Final Comprehensive Field Reconnaissance Report

Demicks Lake Pipeline Right-of-Way
McKenzie County, North Dakota

Project B1904193 (Activity 1.5)

Re: Comprehensive Field Reconnaissance Report
Demicks Lake Pipeline Right-of-Way
McKenzie County, North Dakota

PROFILE VIEW
SCALE: 1" = 50' HORIZONTAL & VERTICAL
BRANCH OF BENNIE PEER CREEK

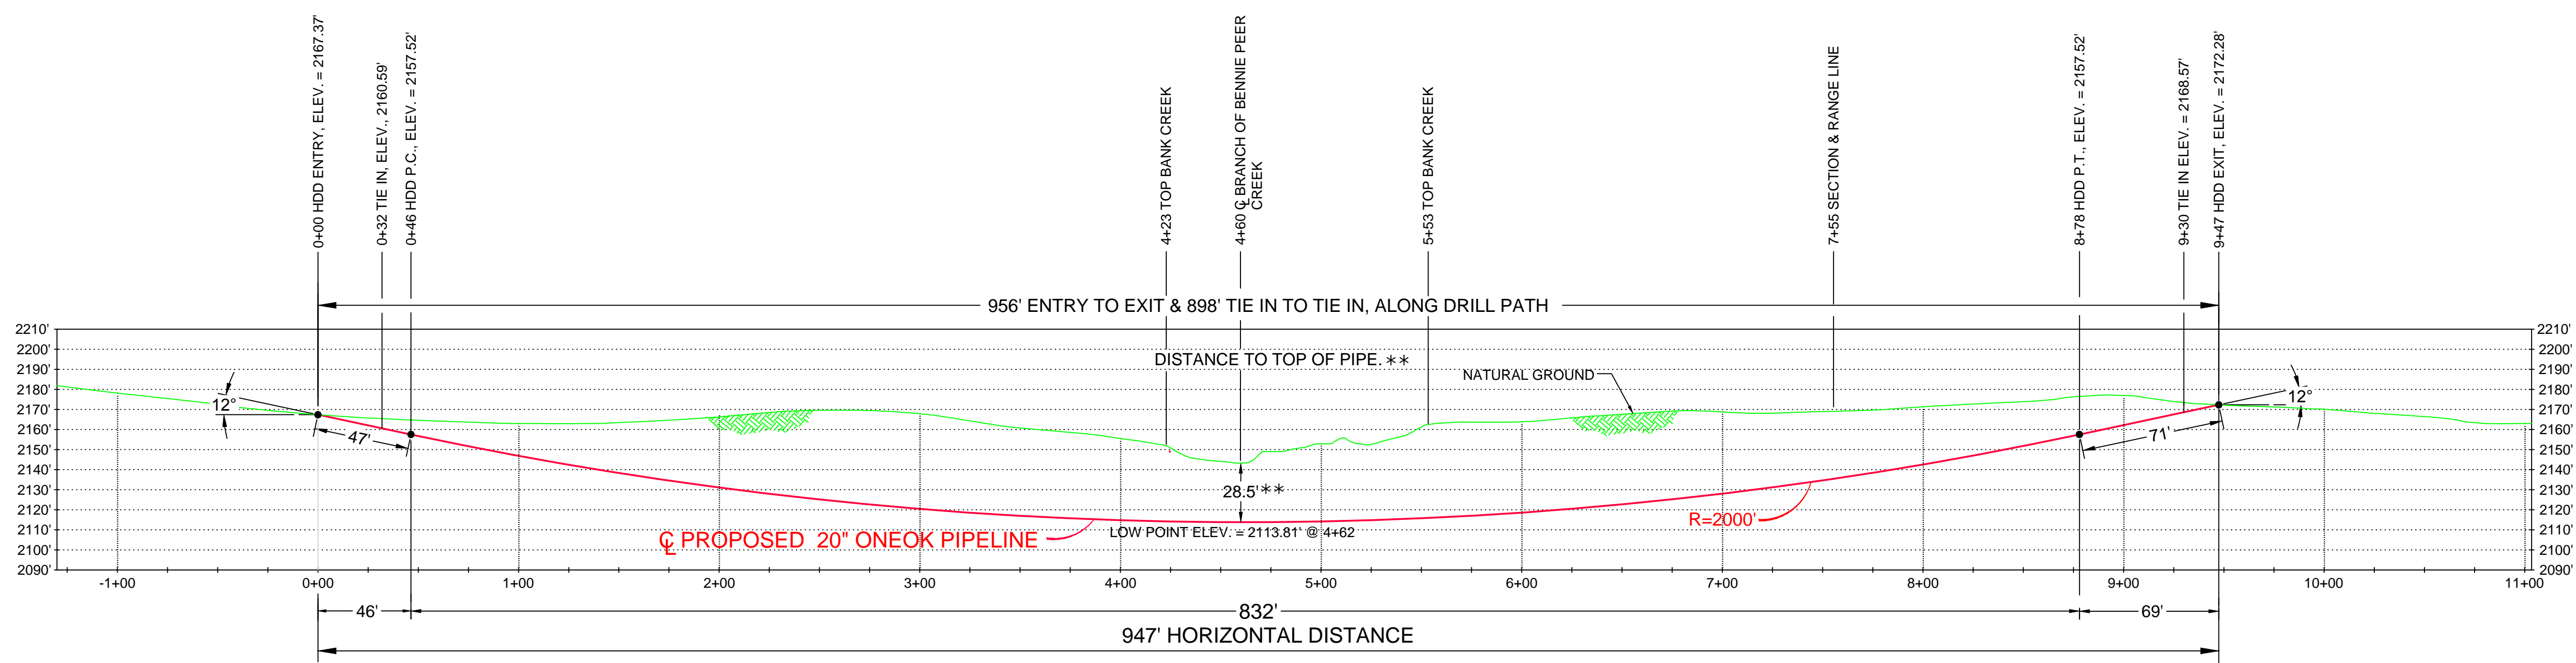
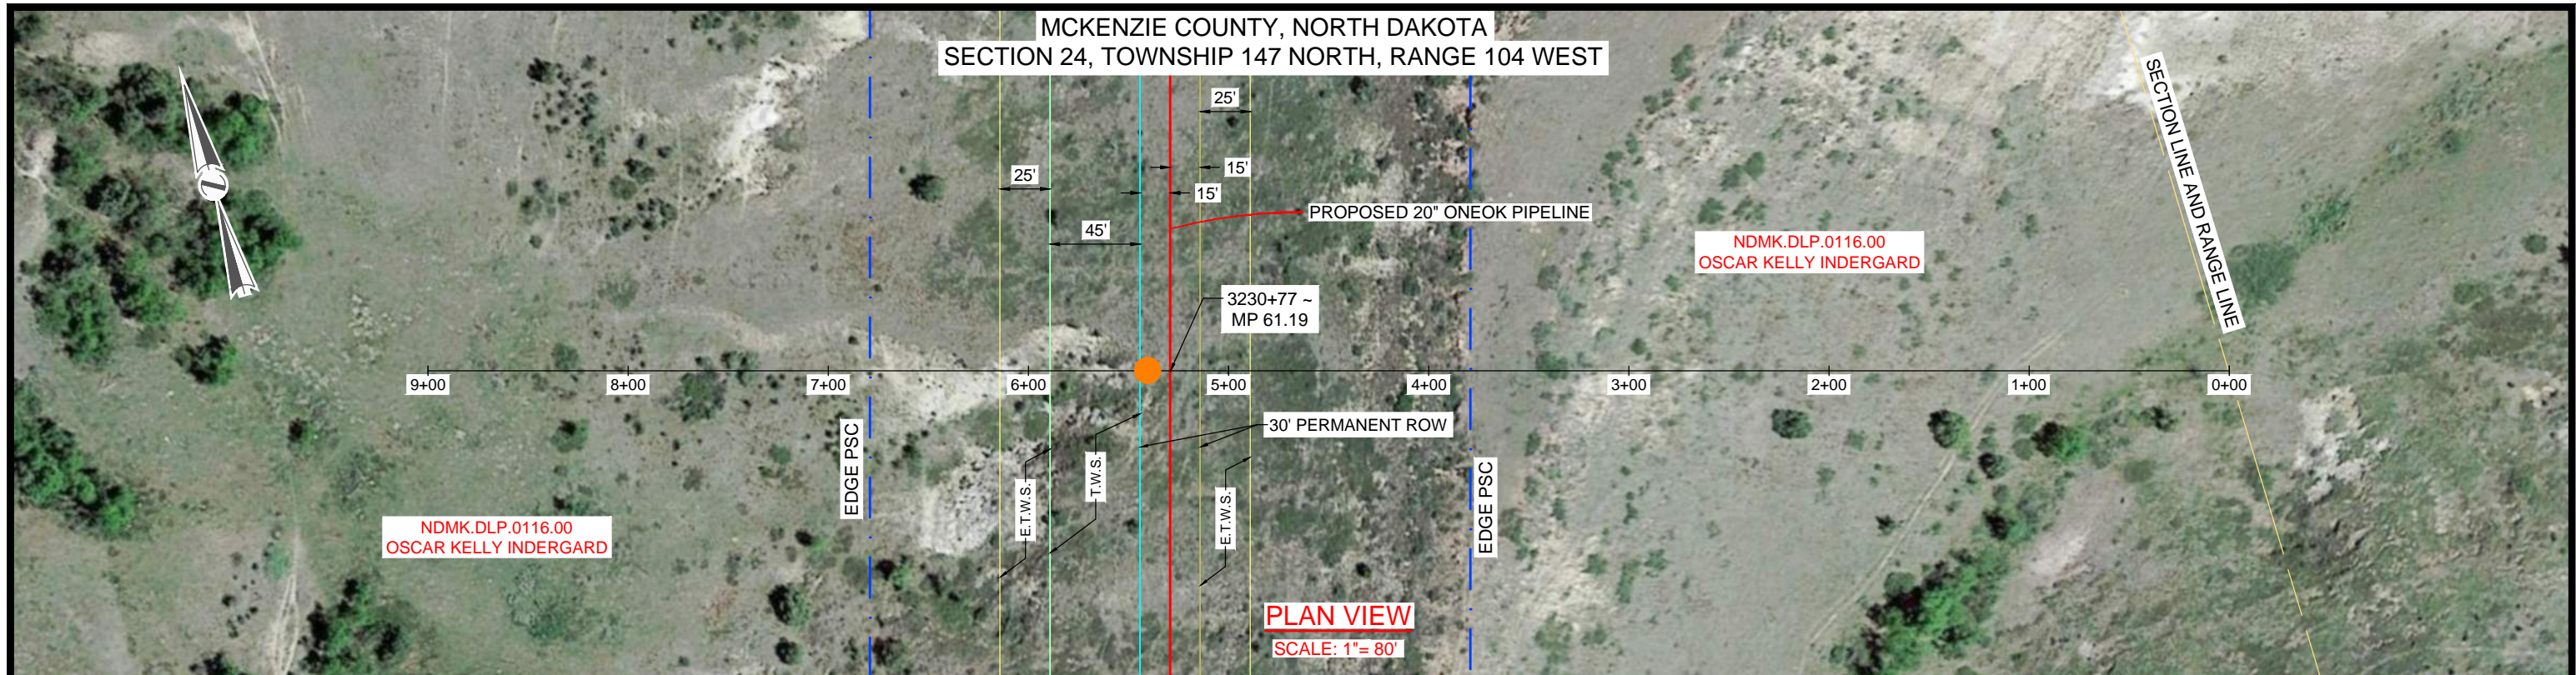
The pipeline near MP60.3 is planned to extend from northeast to southwest directly north of the existing failure area. The horizontal distance of this section will be 947 feet will have a minimum depth of 28 1/2 feet below the bottom of the streambed. Since the existing failure appears to terminate at the bottom of the streambed and the entrance and exit locations of the HDD installation are more than 400 feet away from the failure zone, in our opinion, there is low risk of destabilizing the slope further due to HDD installation and a minimum depth of 28 1/2 feet below the lowest point is suitable.

20" DEMICKS LAKE PIPELINE			
NATURAL GROUND PROFILE CROSSING ROUTE @ MILE POST 61.19 MCKENZIE COUNTY, NORTH DAKOTA			
SCALE	PROJECT NO.	DRAWING NUMBER	REV.
1"=80'	OPL-008	OPL008JTAM-MP-88-022	0

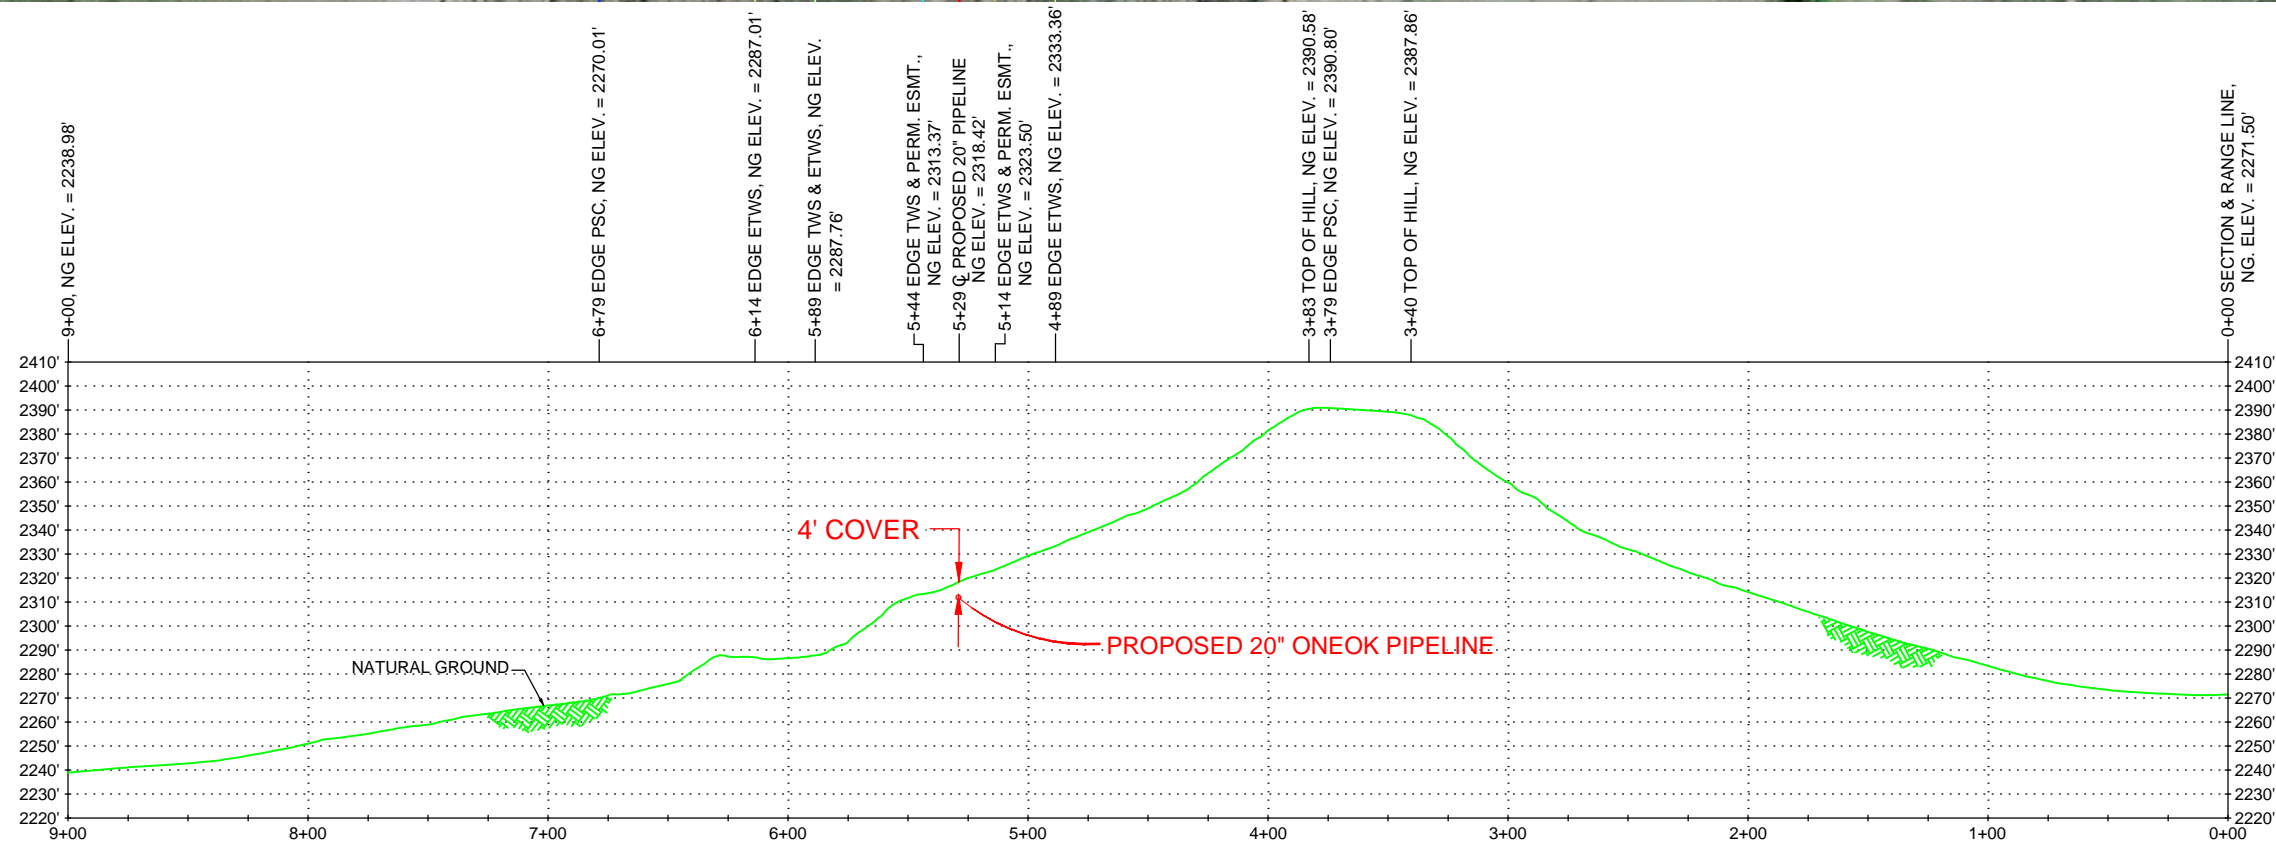
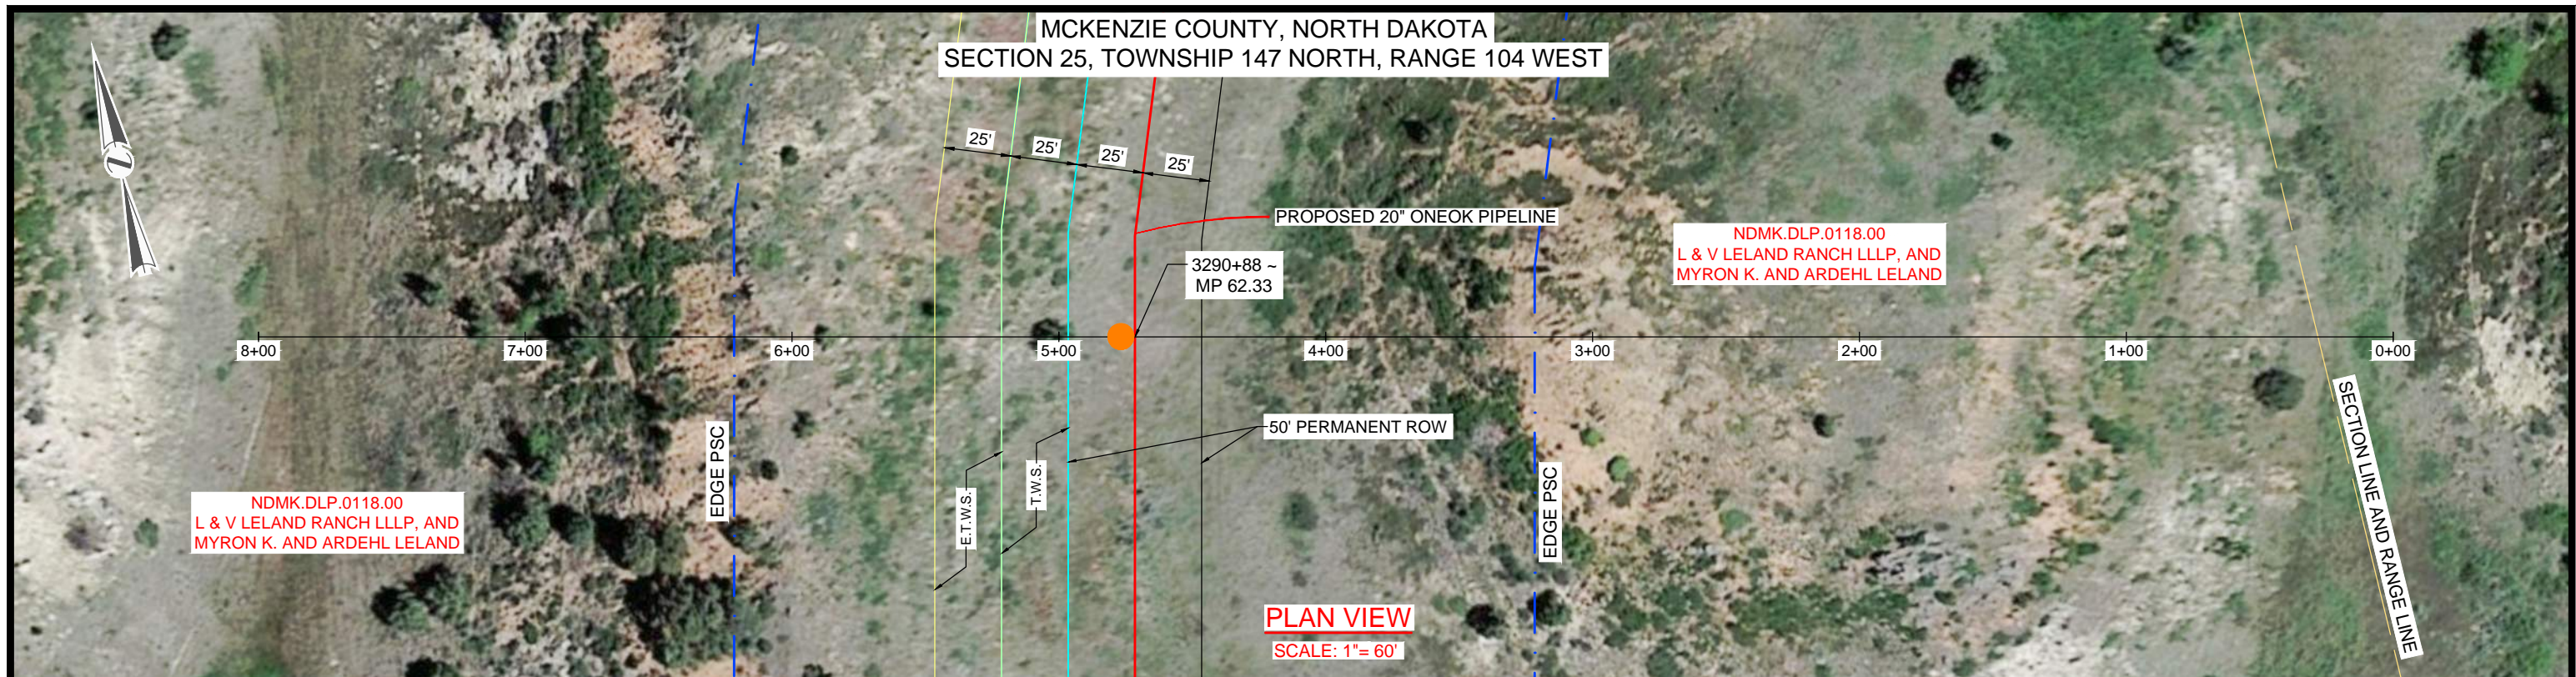
Based on our field observations and construction information provided, there is little concern regarding slope instability at this site. However, similar to MP53.3, care should be taken to not excavate too steeply into the slope and create an unstable situation. Although the native slope of the valley is as steep as 1:1 (H:V) in some locations, we recommend benching the cut slopes to minimize risk of slope instability during construction. Each bench should be less than 4 feet in height. Figure 1 depicts the slope benching technique as described above. The local earth materials are again also highly erodible, warranting long-term slope protection.

The alternative route for this area would be to install the alignment 50 to 100 feet uphill to the east. Since there were no visible signs of slope instability, and the slope is fairly steeper as one proceeds east, we recommend constructing the pipeline in its originally proposed location for ease of construction.
